Item ID: D350-689-023 Accept ***N900040100*** Setup Start ***NS1***
 Revision ID: Stop ***NS2***
 Item Name: Floor Provisions - Energy Attenuating Seat Compatible
 Start Date: 8/28/13 Start Qty: 1.00 ***1*** Cust Item ID:
 Required Date: 8/28/13 Req'd Qty: 1.00 ***1*** Customer:
 Reference:

DART SERVICE INSTRUCTION

TO AMEND INSTALLATION INSTRUCTIONS IIN-D350-689 REV. B AND INSTRUCTIONS FOR CONTINUED AIRWORTHINESS ICA-D350-689 REV. 1

REF. TCCA STC: SH02-33
REF. FAA STC: SR01620NY
REF. EASA STC: EASA.IM.R.S.01453
REF. TCA STC: 2005S03-09

FIGURE 1: UPDATES TO CROSS SECTIONS F-F AND M-M
 With reference to Figures 5 and 7 of IIN-D350-689
 (Figures 25-5 and 25-7 of ICA-D350-689)

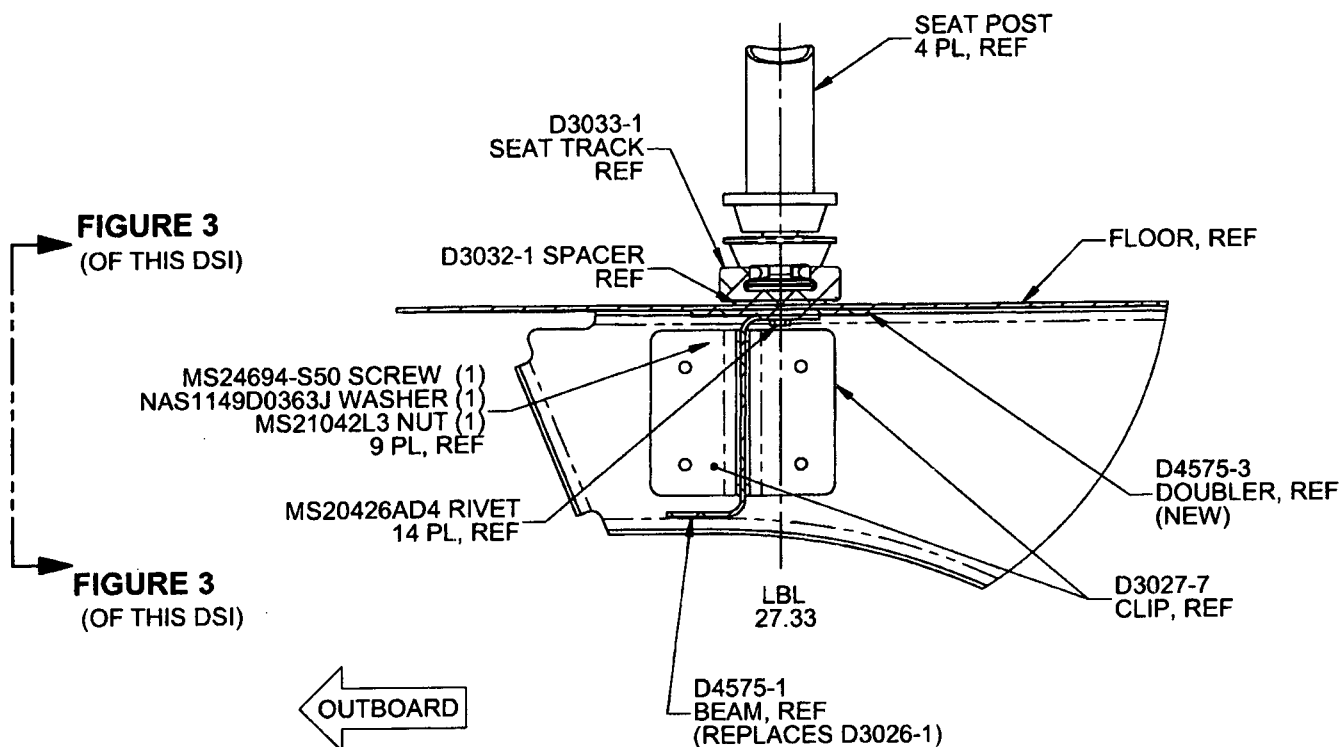
If there is an existing stringer at LBL 27.33, it will need to be removed from that location. Locate D4575-1 Beam, D4575-3 Doubler, and D3032-1 Spacer as shown in Figure 1 of this Service Instruction. Transfer drill existing holes from the aircraft floor to the D4575-1 Beam, D4575-3 Doubler, and D3032-1 Spacer. Ensure 1.0" to 1.5" rivet pitch and add additional holes if required. If there is no existing stringer, locate D4575-1 Beam, D4575-3 Doubler, and D3032-1 Spacer as shown in Figure 1 of this Service Instruction and drill Ø0.128" holes on a 1.0" to 1.5" pitch.

If there is an existing stringer at LBL 27.33, it will need to be removed from that location. Locate D4575-1 Beam and D4575-3 Doubler as shown in Figure 2 of this Service Instruction. Transfer drill existing holes from the aircraft floor to the D4575-1 Beam and D4575-3 Doubler. Ensure 1.0" to 1.5" rivet pitch and add additional holes if required. If there is no existing stringer, locate D4575-1 Beam and D4575-3 Doubler as shown in Figure 1 of this Service Instruction and drill Ø0.128" holes on a 1.0" to 1.5" pitch.

FIGURE 3: RELIEFS ON D4575-1/-3
(ONLY D4575-1/-3 SHOWN FOR CLARITY)
VIEW LOOKING INBOARD

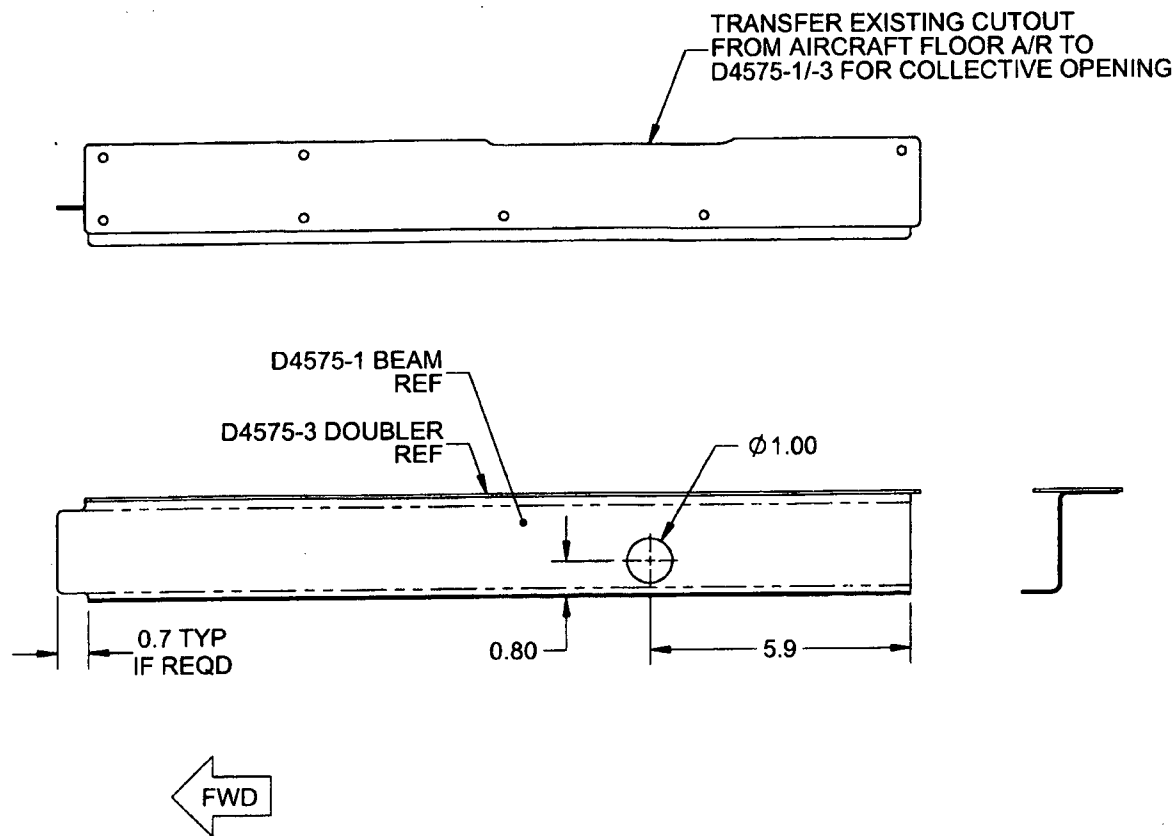
Note: Drill a Ø1.00" (Ø25.4 mm) hole in the D4575-1 Beam to clear extension tube of collective and cutout as required for clearance of collective opening and fwd bulkhead as shown in Figure 3 of this Service Instruction.

Note: Drill a Ø1.00" (Ø25.4 mm) hole in the D4575-1 Beam to clear extension tube of collective and cutout as required for clearance of collective opening and fwd bulkhead as shown in Figure 3 of this Service Instruction.
